AGENDA
PLANNING AND ZONING COMMISSION MEETING
CITY OF CREVE COEUR, MISSOURI
MONDAY, SEPTEMBER 16, 2013
7:00 PM

A. Application #13-003: Request for Boundary Adjustment and Rezoning of 5.26 Acres to “CB” Core Business District, and a Conditional Use Permit for “The Vanguard of at Creve Coeur” Multi-Family Residential Development.

**APPLICATION TO PLANNING AND ZONING COMMISSION
#13-003 FOR BOUNDARY ADJUSTMENT AND REZONING OF 5.26 ACRES
TO "CB" CORE BUSINESS DISTRICT, AND A CONDITIONAL USE PERMIT
FOR "THE VANGUARD OF AT CREVE COEUR" MULTI-FAMILY
RESIDENTIAL DEVELOPMENT**

Figure 2: Proposed Lot Configuration

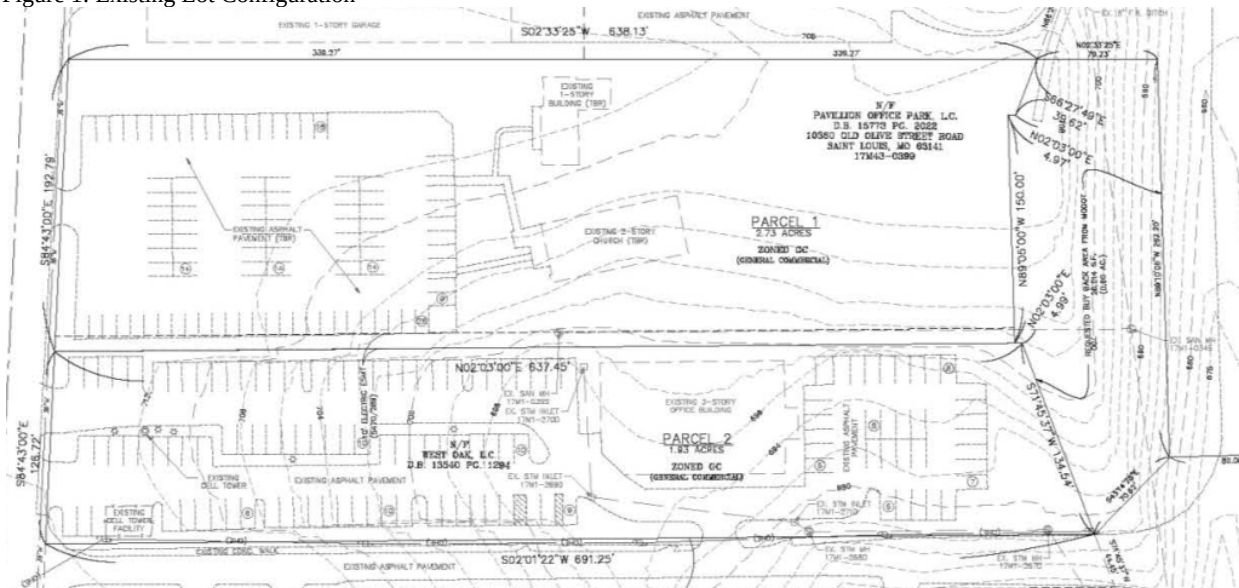
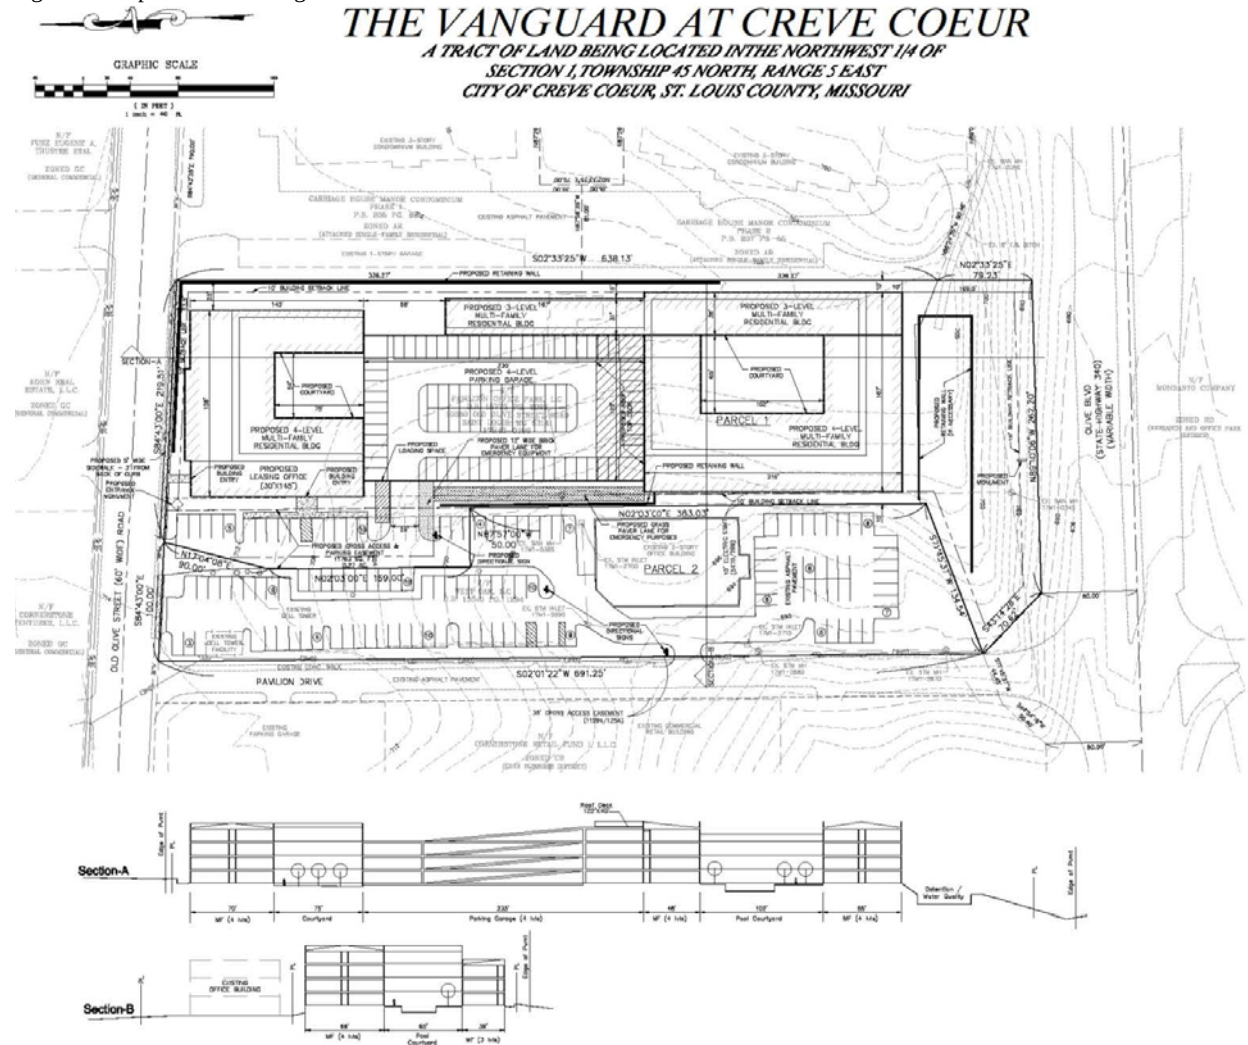
The proposal does include a boundary adjustment between the two lots although it is not shown on its own drawing. The effect of the adjustment is to increase the area of the apartments’ lot to at least three acres, while maintaining frontage on Old Olive Street Road for the office building. In the end, the sharing of access and parking across the property lines effectively obscures the distinctions between the properties, and the boundary adjustment should be viewed as a single project. It is typical in commercial developments, where there is a substantial sharing of facilities, for the property lines to largely follow economic priorities rather than a simple, conventional lotting pattern. The site development drawing appears to meet the technical requirements for a boundary adjustment so the adjustment can be approved subject to the condition that a final boundary adjustment plat be prepared for signature prior to recording.

Figure 3: East Elevation

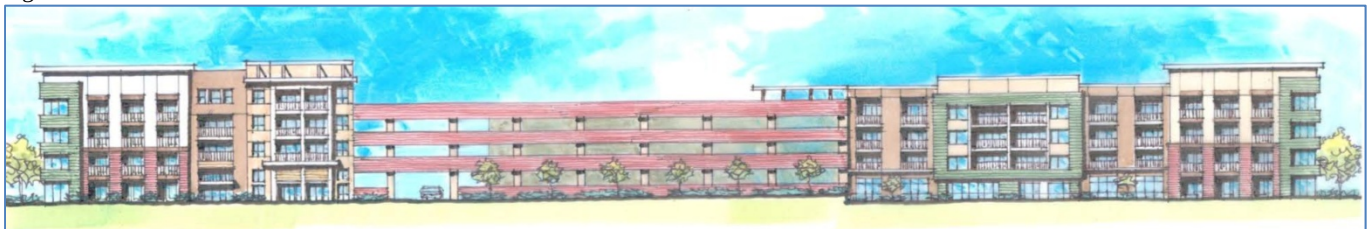
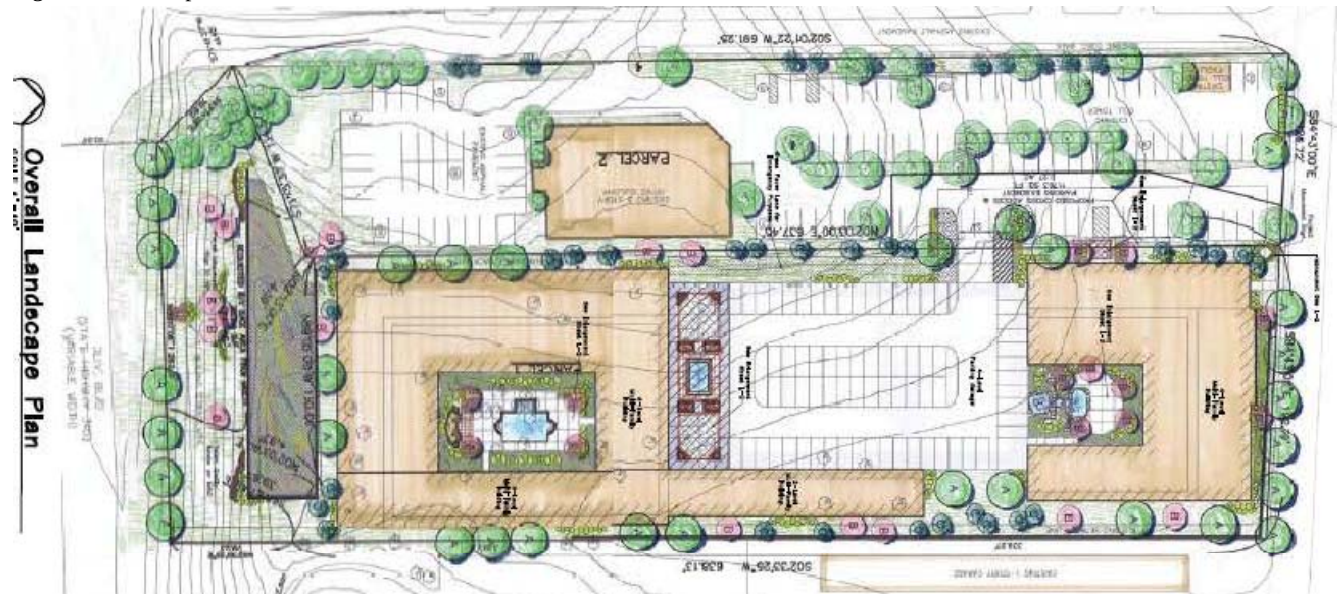
The revised structure has a greater articulation of elevations and variety in the roof-line that is recommended by the Design Guidelines. All sides of the building have equal merit, and the landscape along Olive Boulevard has been revised to include the required street trees and a mix of ornamental trees and shrubs on the hillside to more closely address the “green-line park” objective for Olive Boulevard. Currently, MoDOT does not recommend the installation of sidewalks along Olive Boulevard in this location since there are no pedestrian facilities on the Olive Boulevard bridge over Lindbergh Boulevard. It is their preference that all pedestrians move only to the west via Old Olive Street Road. Appropriately, the applicant is proposing street trees along Old Olive Street Road and a new, detached sidewalk is still included. Finally, the surface parking lot shared with the adjacent office building includes extensive interior landscaping and planted breaks in the rows of parking stalls.

Figure 8: Sky Exposure Plane

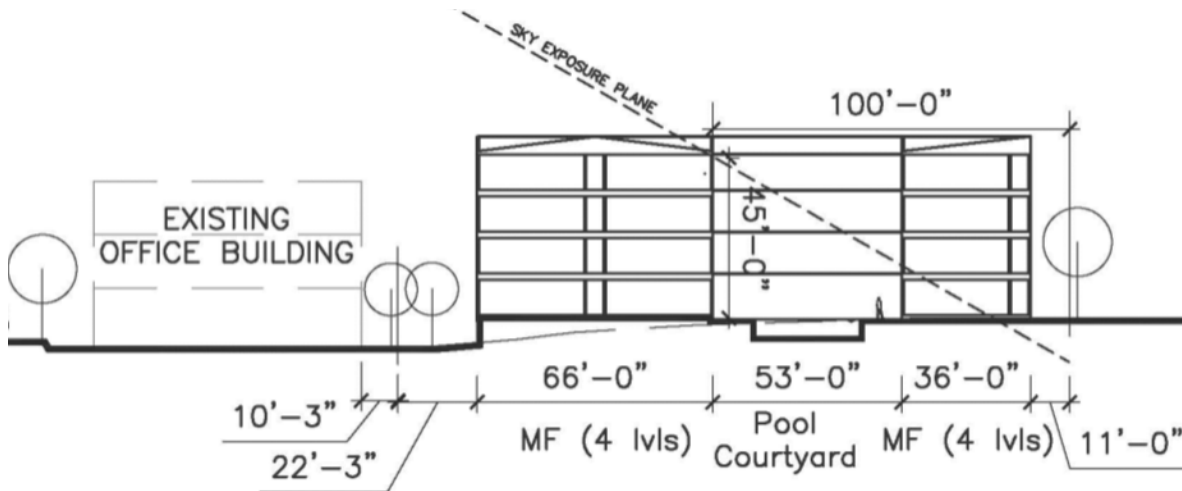
The portions of the building above the dashed line labeled “Sky Exposure Plane” are not permissible under this regulation. A variance will be required to build in that area.
